**1 Products affected**

**2 Type of change**

Product Change Notification					PCN 4798		
owner	creation date	release date	released by	change order no	rev	page	0118.2322
hotzar	2015-12-05	2016-03-14	stadelt1	2009470	A	1 of 2

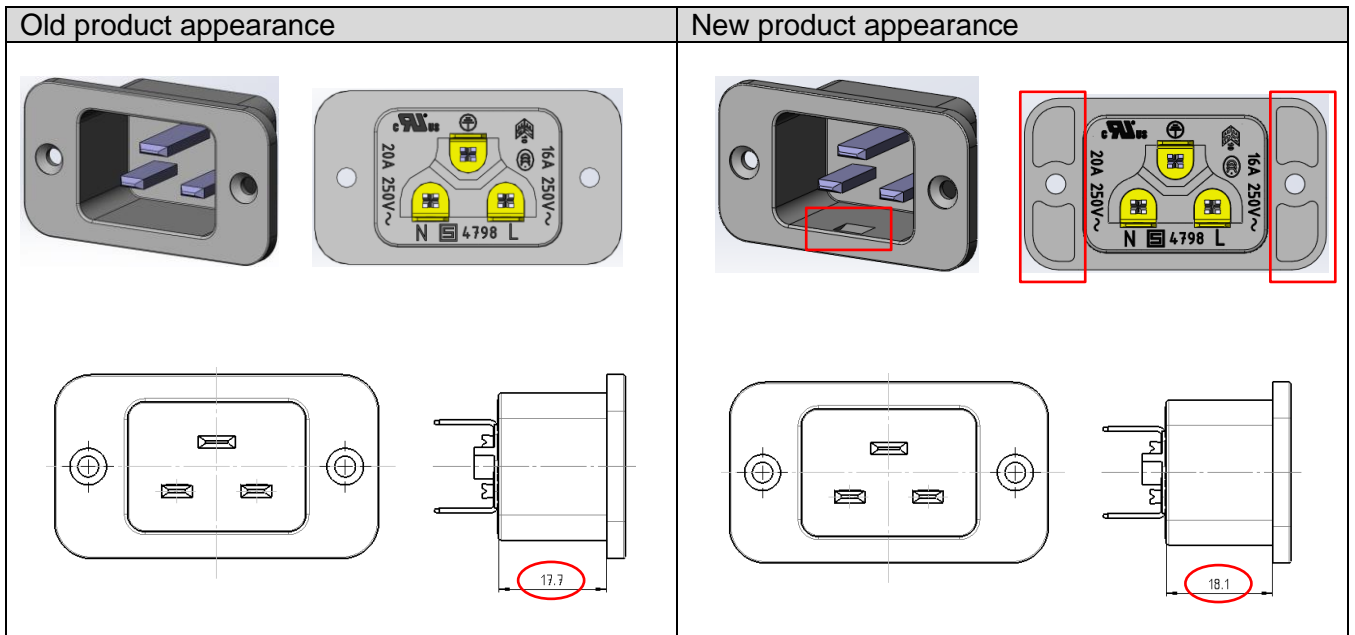
- Material change from PA6 to PA66/6 to pass the enhanced requirements of glow wire test acc. to IEC 60695-2-12 and -13
- V-Lock feature integrated as standard (not an option anymore)
- Flange will have a new form on the back side to improve molding process.

Form	Yes	Yes Socket has notch for V-Lock cord retaining, flange new form on the back side, extended socket dimension.
Fit	Yes	Yes, installation depth is 0.4 mm extended.
Function	Yes	V-Lock feature is standard (not an option anymore)
Production Site	No	There is no change of the production site
Product Label	No	No label change
Customer Action	No	Check installation depth in the application. Change SCHURTER part number if affected.
